Product Change Notification

Change Notification #: 109028 - 01
Change Title: DG35EC, PCN 109028-01, Product Design, Video circuit enhancement, Reason for Revision: Correct AA dash for BOXDG35EC
Date of Publication: December 01, 2008

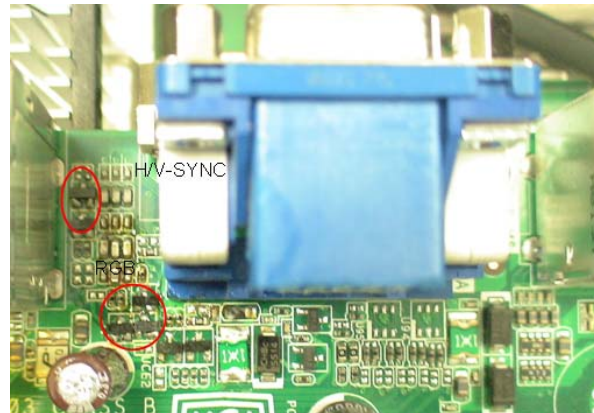
To enhance the video circuitry, a diode package is being added to the RBG/H/V-Sync signals.
